Hi-Fi Products Service Bulletin

Model: All CDP/CDP-C

No. 286R1

Subject: Will Not Play Disc / Skips After Optical Block Replacement

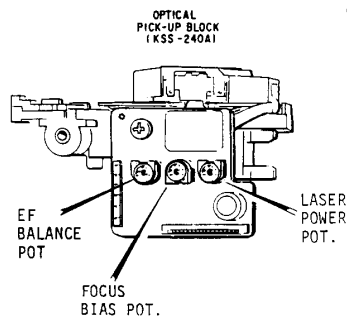
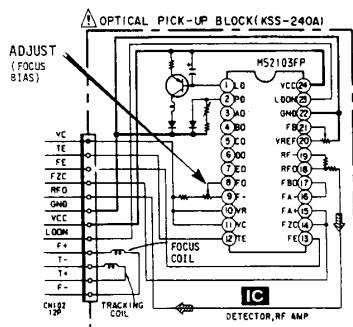
Symptom:
(12) Unit will not read TOC or unit will skip after optical block has been replaced.

Solution: Focus Bias is out of adjustment. Adjust focus bias pot on optical block KSS-240A as follows:

1. Use a YEDS-18 disc.
2. Adjust the focus bias pot for the clearest eye pattern.

Clear RF signal waveform means that the shape "◇" can be clearly distinguished at the center of the waveform.
